COUNCIL BILL NO. 3149

ORDINANCE NO. 2588

AN ORDINANCE ANNEXING APPROXIMATELY 31.13 ACRES OF TERRITORY KNOWN AS THE SCHULTZ FARM PROPERTY WITH NO STREET ADDRESS INTO THE CITY OF WOODBURN, LOCATED ALONG THE WEST SIDE OF BOONES FERRY ROAD NE NORTH OF HAZELNUT DRIVE, MARION COUNTY, OREGON

Image 102B - Dove Landing parkland

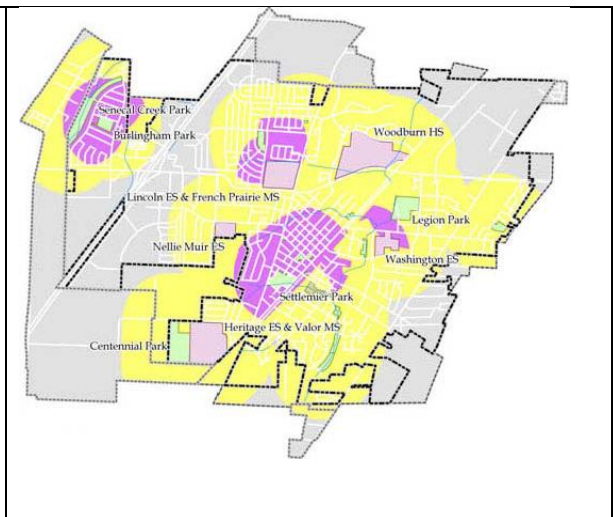
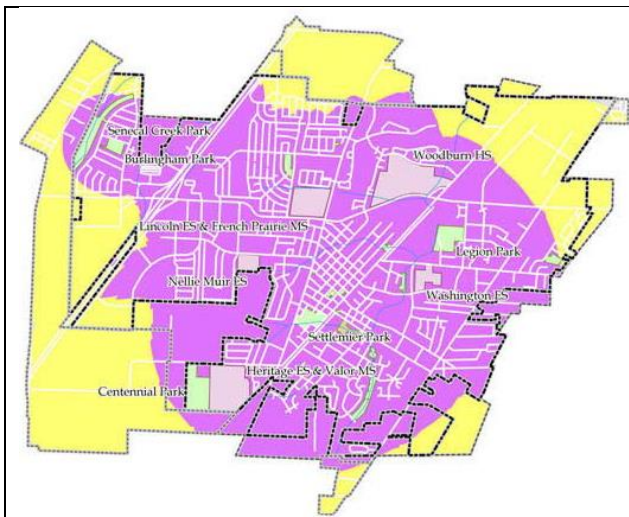
The Dove Landing parkland map represents the City/pub parkland Tracts I & K, which total 8.32 acres, in dark green in relation to existing City parks in light green.

The total 8.32 acres of Tracts I & K, with Tract K being the larger one at 7.2 acres, appeals to the Assistant City Administrator as parks director in that the size can easily fit regional facilities were the City to later construct or install them. The two tracts are 26.7% of the gross site area in the context of PUD standard of 30% open space. The remaining tracts as common areas compose the total of 33% per land use review plan Sheet 4 that the developer proposes as open space.

Image 102E-1 – Dove Landing close-up

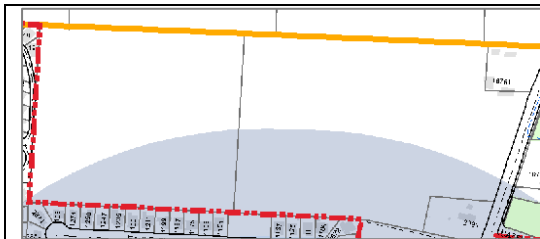
Compared with the Dove Landing site plan, the majority of lots would be beyond the outermost crow-fly buffer of the nearest park, which is Heritage Park. The walking distance of 0.7 miles more than twice exceeds the 0.33 mile buffer distance. Staff emphasizes that access to parks isn't merely about proximity of future residents of Dove Landing to public parks, but also providing adequate parks level of service for existing residents based on the desires and

Exhibit PUD-3c: Sidewalks (blue: min 8 ft wide)

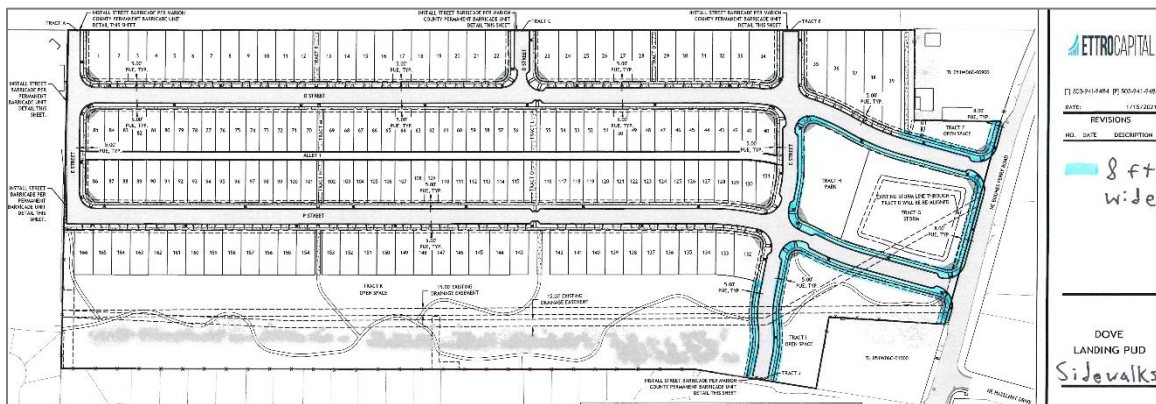
- a. BFR: Per WDO Fig. 3.01C except that planter strip shall be min 6½ ft wide inc. curb width.
- b. Planter strip remainder: Remaining ground not occupied by trees shall be planted with lawn grass.
- c. Sidewalks: Min 6 ft wide except wider as Exhibit PUD-3c supersedes. The BFR sidewalk dead-end(s) and “P” Street west dead-end shall have ADA-compliant transitions spanning between sidewalk and road shoulder. If PW were to direct during CEP review that the road crossing of the culvert have curb-tight sidewalk, min width shall be 8 ft.

Exhibit PUD-3e: Street Tree Min No. (green: equal to 1 tree per 30 ft of block frontage)

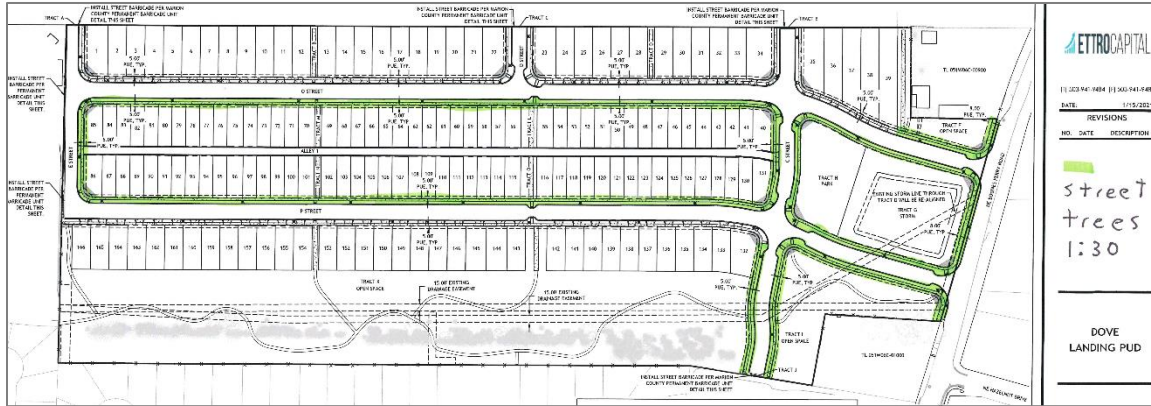
- d. Overlap: The extra width of planter strip and sidewalk shall either (1) overlap outside ROW into streetside PUE and where applicable Tracts I & K or (2) come with additional ROW to accommodate them. Wider sidewalks shall not narrow planter strips.
- e. Street trees: Min numbers equal to block frontage ratios per Exhibit PUD-3e.

Exhibit PUD-3g: Patterned Poured Concrete Crosswalks (symbolized in blue)

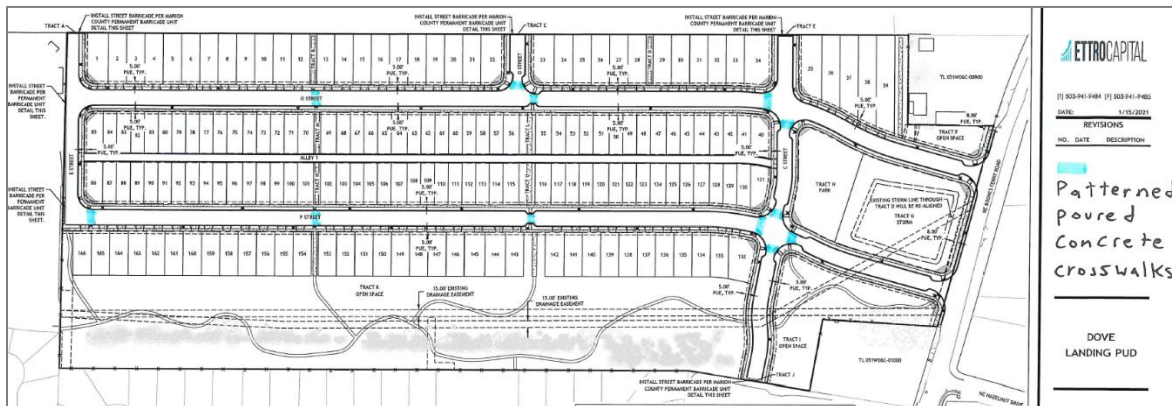
(2) Crosswalks / pedestrian crossings along intersection legs per Exhibit PUD-3g shall be patterned poured concrete each min 8 ft wide.
